Teletype Corporation Skokie, Illinois, U.S.A. Specification 50218S Issue 1, Page 1 March, 1964

# INSTRUCTIONS FOR INSTALLING THE 182044 MODIFICATION KIT TO PROVIDE MODEL 33 PRINTER SET WITH AN ELAPSED TIME INDICATOR

FIGURE 1. 182044 MODIFICATION KIT

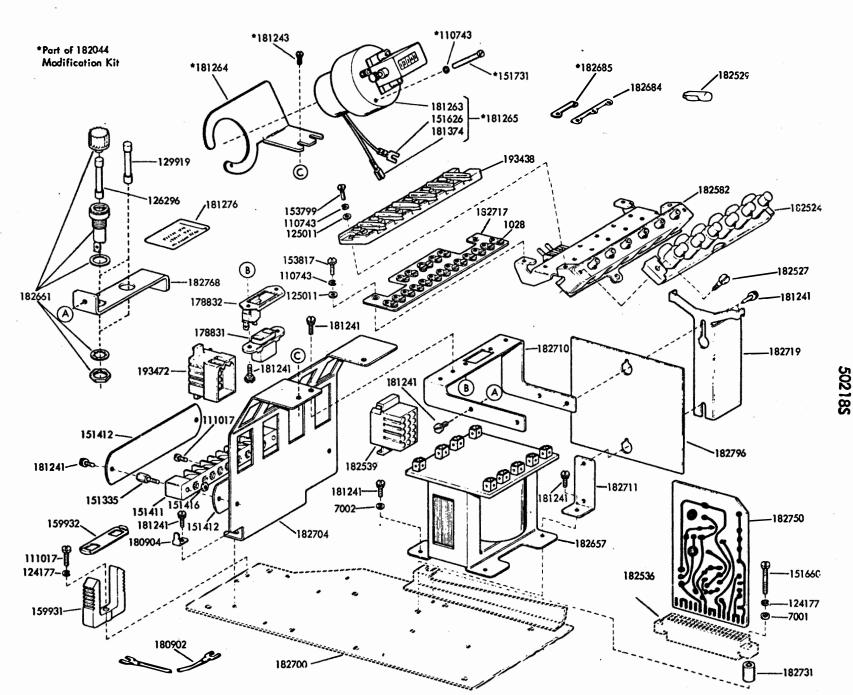
a. Place the 181265 Timer Assembly with the counter up and the wire leads to the left into the large hole of the 181264 Bracket, holding the bracket as it appears in Figure 1. Rotate the timer counter-clockwise until the numbers on the counter are horizontal (normal reading position) and assemble the 110743 Lock Washer and 151731 Screw in the lower left hand hole in the counter and screw it in the tapped hole in the bracket.

c. Slide the 181264 Bracket under the two loosened screws and tighten same screws making sure the two wire leads from the timer are not pinched by the bracket assembly. (See Figure 2)

As per Figure 2, route the two wire leads from 181265 Timer to terminal 1 of the 182657 Power Transformer and terminal 9 of the 151411 Terminal Strip. Also, route the 182287 Wire Strap to terminal 4 of the 182669 MCR Relay and terminal 9 of the 151411 Terminal Strip. Make certain the wire leads do not interfere with the distributor 180980 Brush Holder.
